Name	Company	Email
To	Michael Azar	Ecove	michael@ecove.com.au
	Charmaine Pang	Bates Smart	cpang@batesmart.com
	Andrew Brohier	McKenzie Group Consulting	abrohier@mckenzie-group.com.au
Date	20/07/2016	Job no SY150512	Version CA1.6
Project	Site 9 – Sydney Olympic Park

1. Introduction

We have prepared this advice to identify and document the fire safety measures that are likely to be required for the proposed residential tower development at Site 9, Sydney Olympic Park to achieve compliance with the performance requirements of the National Construction Code Series 2015 Volume One – Building Code of Australia (BCA)¹. This review is based on the documentation listed in Appendix A.

Figure 1 Ground floor retail fire separation

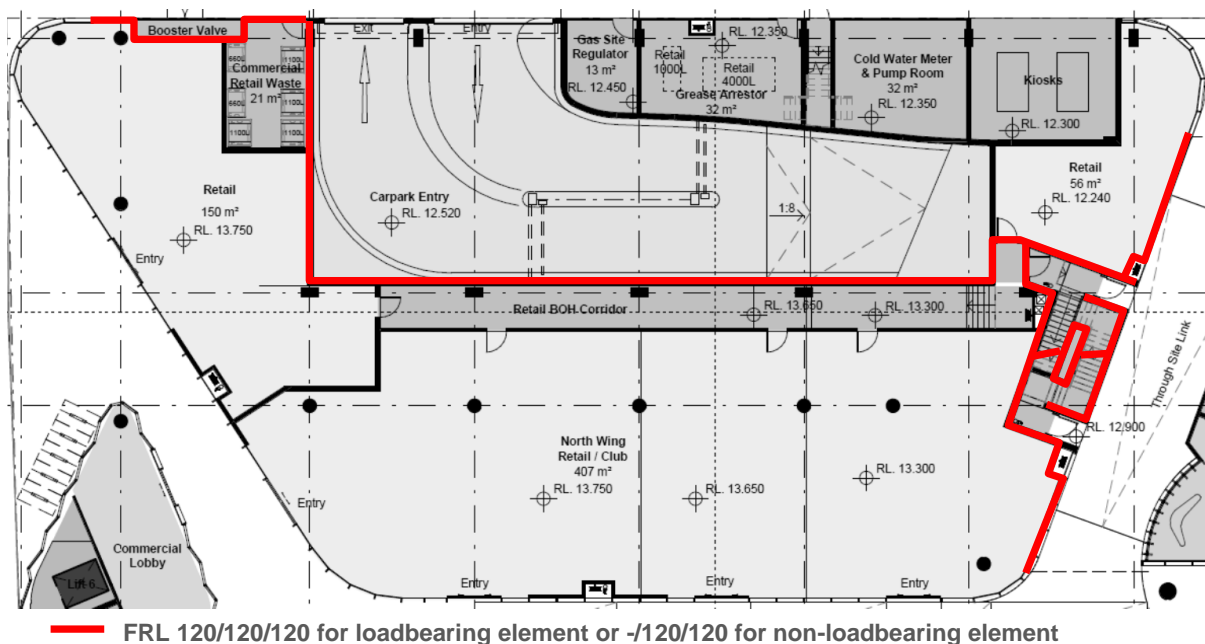
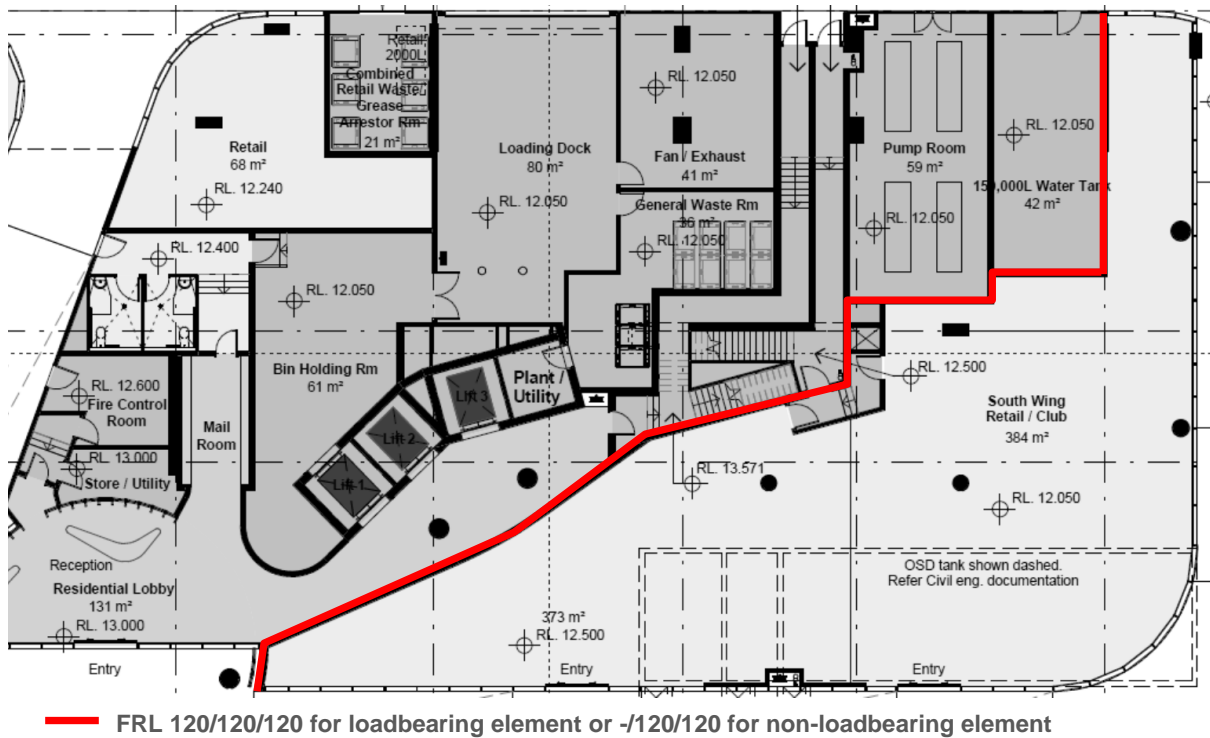
4. The retail areas on the ground floor must be separated from the other classifications on the storey by a fire wall and floor above that achieve an FRL of not less than 120/120/120 instead of 180/180/180 as required by clauses C2.7, C2.8 and C2.9 of the BCA. Refer to **Figure 1**.

18. The proposed location of the fire hydrant booster assembly adjacent to the carpark entry as shown in **Figure 1** is not considered comply with AS 2419.1-2005 as it is not within sight of the main entry to the building being the main residential entry lobby.

Figure 2 Levels 7-9 and 36-38 maximum travel distance to a point of choice

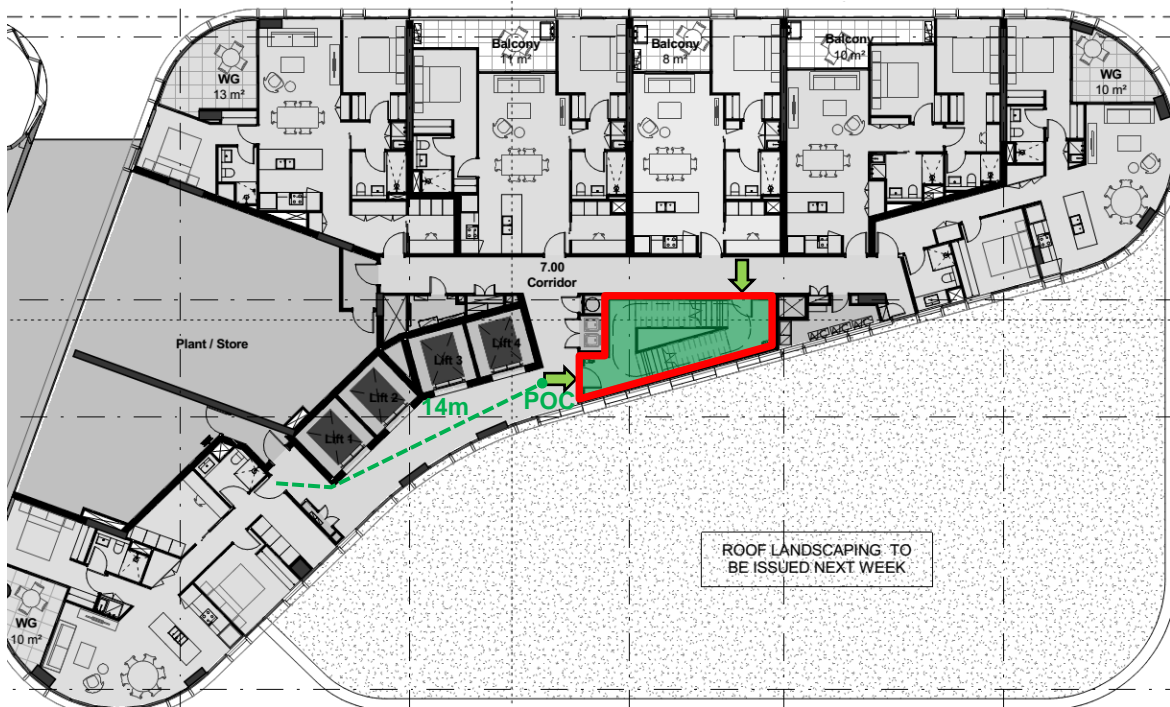
6. Each storey including the commercial portions on levels 7 and 8 must be served by a minimum of two fire-isolated exits in accordance with clause D1.2 of the BCA.
7. The maximum travel distance to a point of choice within the residential corridors may be extended to:
 - a. 14m instead of 6m from the furthest apartment on levels 7-9 and 36-38 provided occupants need not travel past another apartment before reaching a point of choice as shown in Figure 2.
 - b. 15m instead of 6m from the furthest apartment on levels 10-35 provided occupants need not travel past more than one apartment before reaching a point of choice as shown in Figure 3.

Figure 4 Maximum travel distance to nearest exit on the podium carpark levels 3 to 6

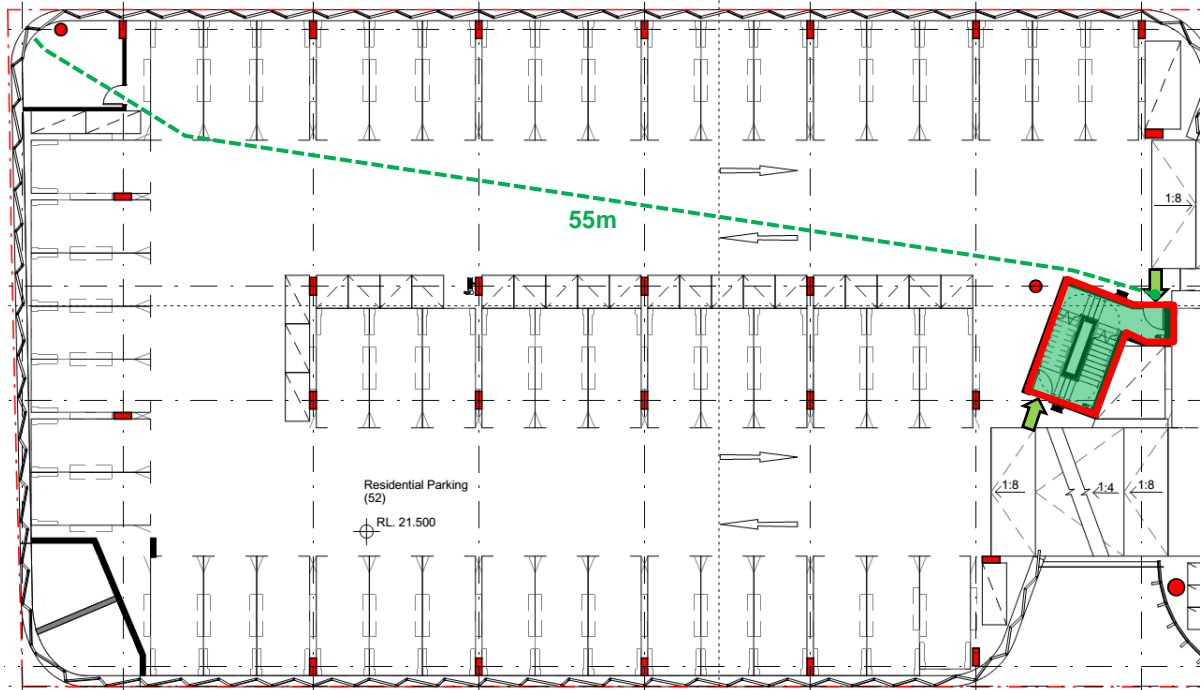
8. The following maximum travel distances apply within the podium carpark levels of the building:
 - a. 20m to a single exit or point of choice
 - b. 55m to the closest of two or more alternative exits
 - c. 60m between alternative exits.

Figure 5 Maximum travel distance to nearest exit on commercial levels 7 and 8

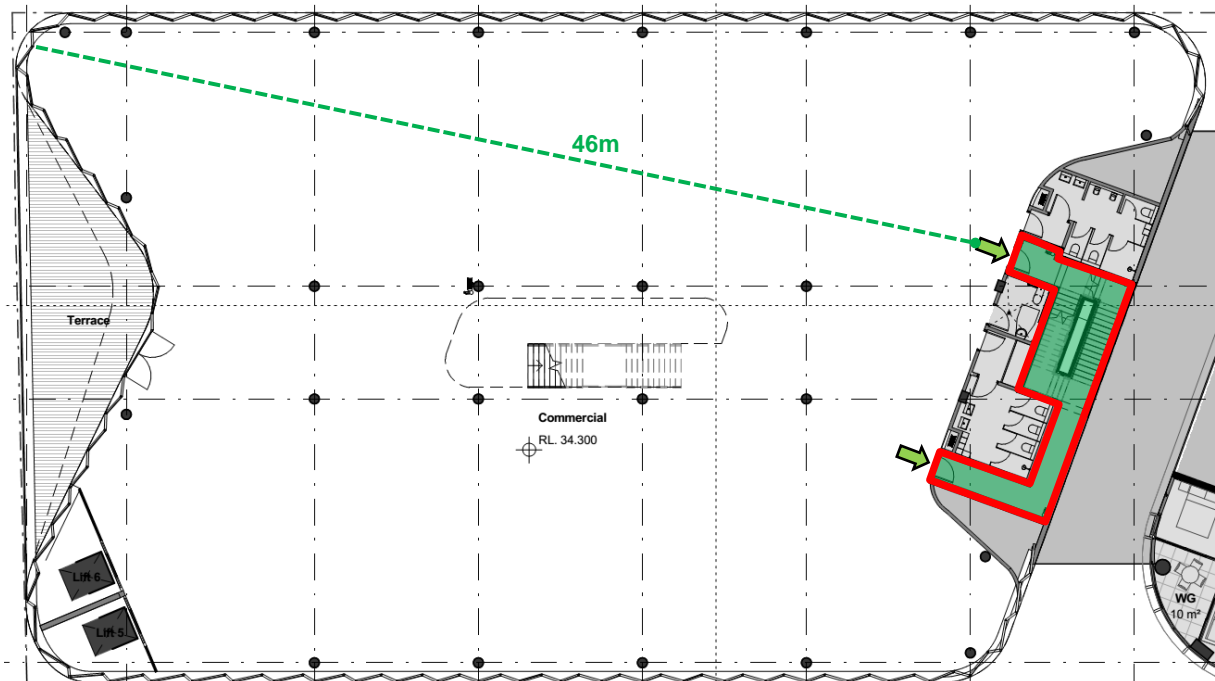
9. The following maximum travel distances apply within the commercial office levels of the building:
- a. 20m to a single exit or point of choice
 - b. 50m to the closest of two or more alternative exits including fitout
 - c. 60m between alternative exits.

Figure 6 Residential courtyard on level 9

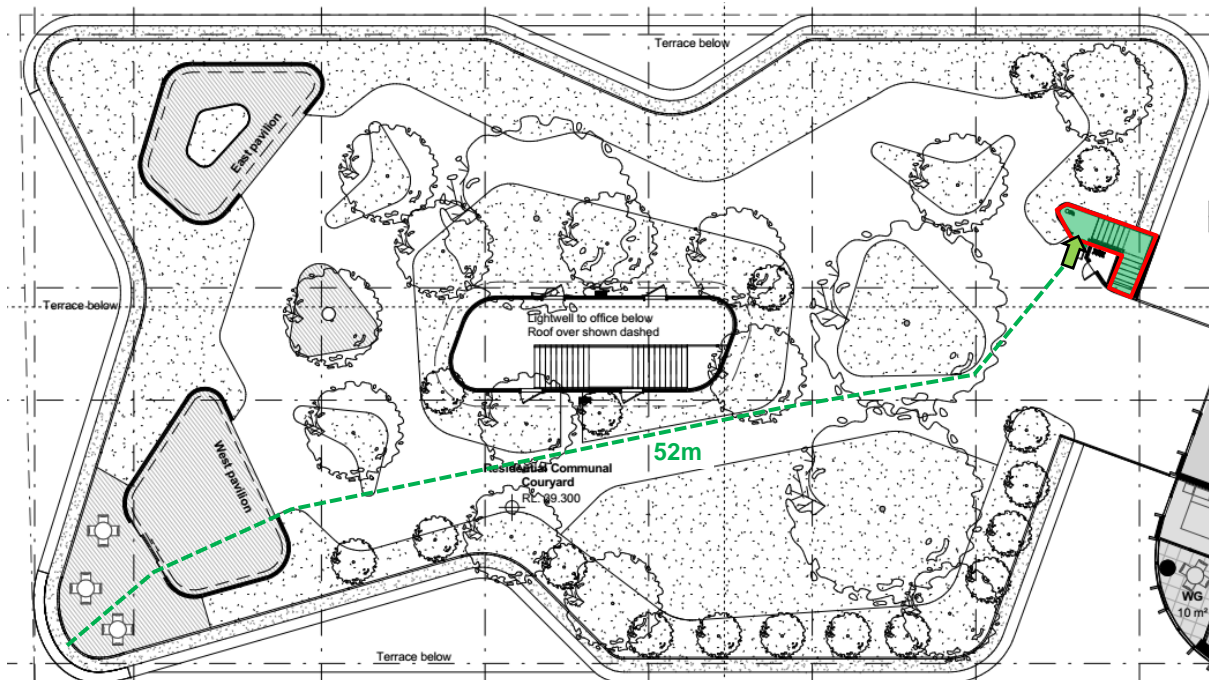
10. The maximum travel distance to the nearest exit from the residential courtyard on level 9 may be extended to 52m in lieu of 20m as shown in Figure 6 provided the following requirements are met:
- The floor of the roof must achieve an FRL of 120/120/120 in accordance with clause D2.12 of the BCA.
 - The courtyard is fully opened to the sky.
 - The sound system and intercom system for emergency purposes must be audible throughout the courtyard.

Figure 7 Level 39 lobby

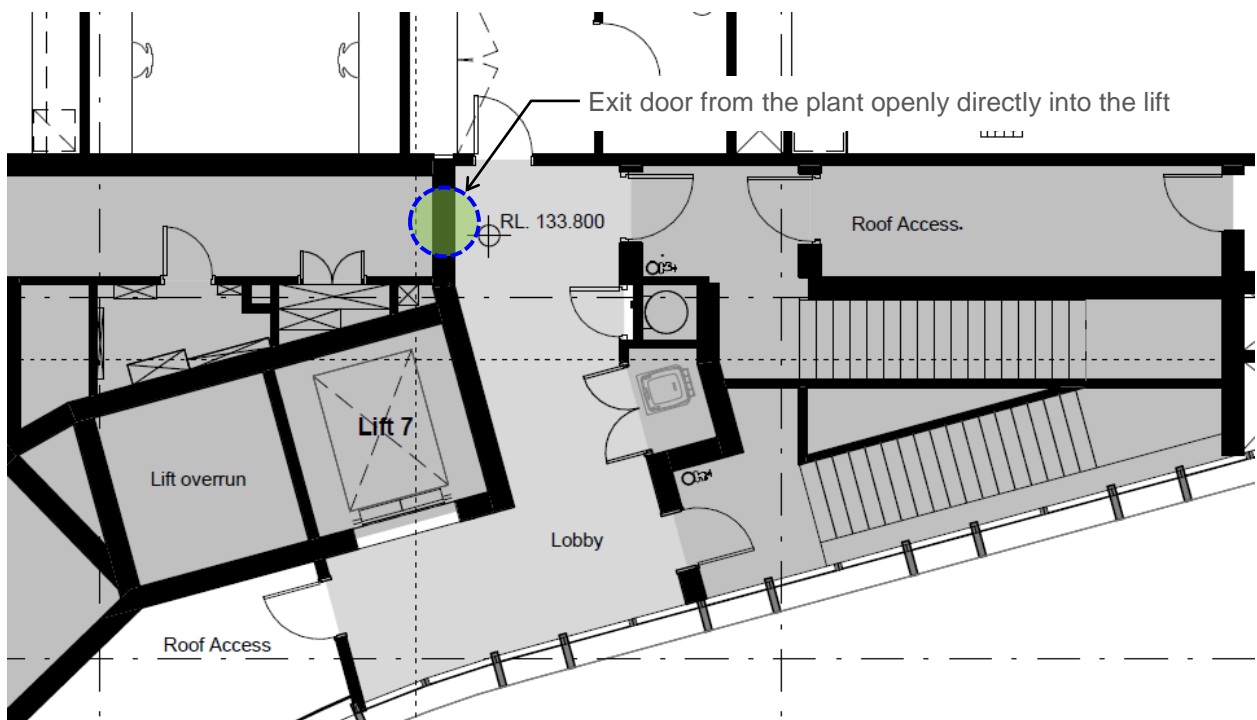
11. The maximum travel distance to a point of choice/nearest exit from the plant areas on levels 7 and 8 may be extended to 27m in lieu of 20m.
12. The two entries to the fire-isolated scissor stair serving level 39 of the building may be located 4m apart in lieu of 9m provided a doorway is provided between the plant room and the lift lobby as shown in Figure 7. This doorway is to be protected by a self-closing FRL -/60/30 fire door which may swing inwards into the plant room.

Figure 8 Discharge of fire isolated stairs into covered through site link

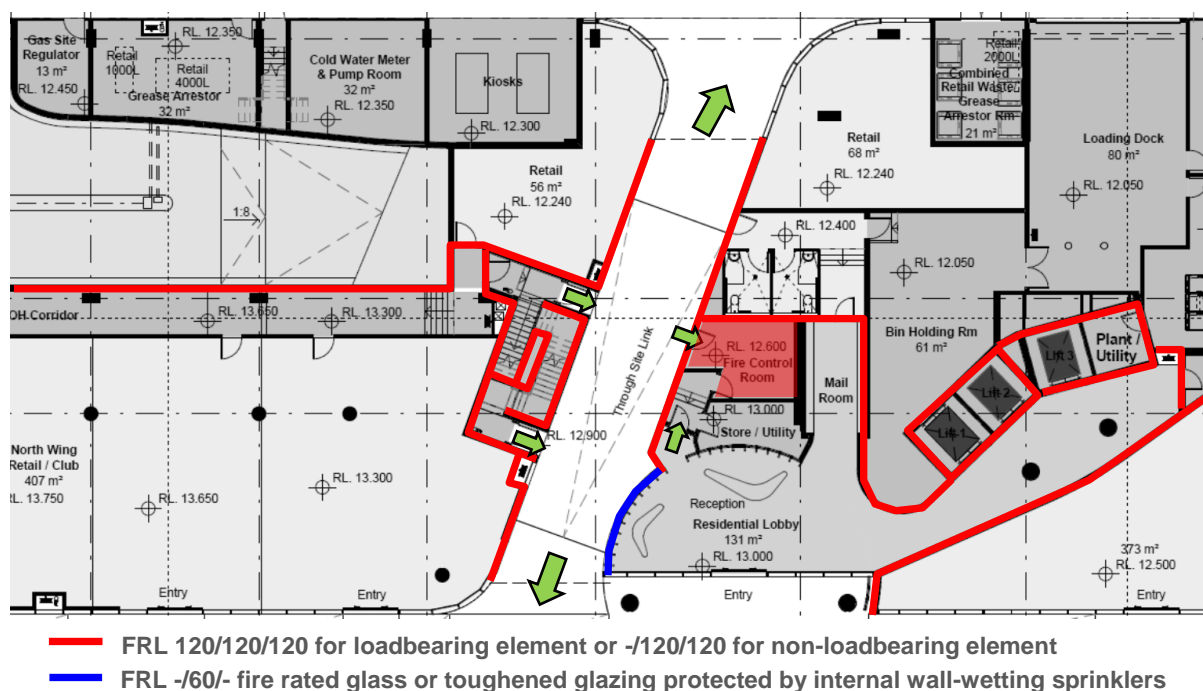
13. The two fire-isolated stairs serving the low rise portion of the building may discharge into the covered through site link which is not open for at least 1/3 of its perimeter provided the following requirements are met:

- a. Openings must have a total clear width of 9m comprising of the two openings at either end of the through link
 - b. Has an unobstructed clear height throughout, including the perimeter openings, of not less than 3m

- c. The internal walls bounding the through site link must achieve an FRL of 120/120/120 or -/120/120 if the walls are non-loadbearing
 - d. Glazing in the internal walls between the entry lobby and the through site link is permitted provided it is FRL -/60/- fire rated glass or 10mm toughened glazing protected on the inside by quick response Tyco Model WS™ 5.6 K-factor pendent vertical or horizontal sidewall sprinkler heads

- e. Doorways opening into the through site link must be protected by self or automatic closing FRL -/120/30 fire doors
 - f. The residential entry lobby must be fire separated from the bike store as shown in Figure 8

- Note: The proposed location of the fire hydrant booster will need to be referred to FRNSW for approval.**
19. The building is required to be provided with a fire control room in accordance with clause E1.8 of the BCA. The fire control room is proposed to be accessed via the through site link and the residential entry lobby as shown in **Figure 8**.
